Access Compliance Report Public Rights-of-Way (Curb Ramps)

Main Street: **HAMER_DR** Cross Street: **SHADBURN_AVE** Location: **NE**

ADA ID: **RPAT210917124220** Ramp Type: **Type 1 - Perpendicular Diagonal** Initial Pass/Fail: **Pass** Overall Compliance: **No** Severity Score: **4**

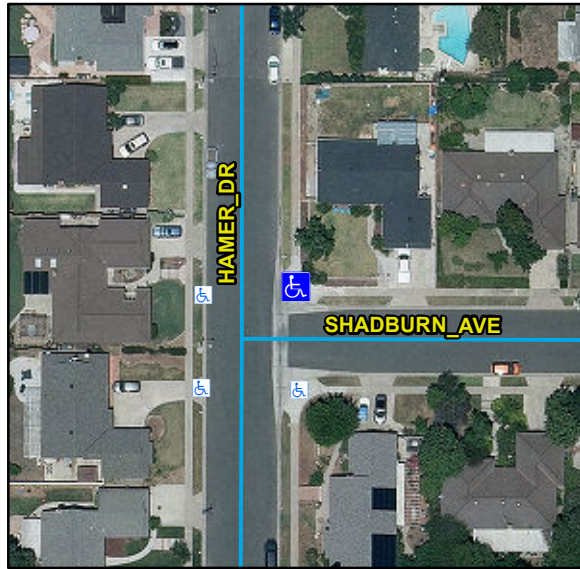
Possible Solutions:

Remove & Replace Curb Ramp With Two New Directional Ramps or Equivalent.

R304.2.2, R304.2.1, STD 1115
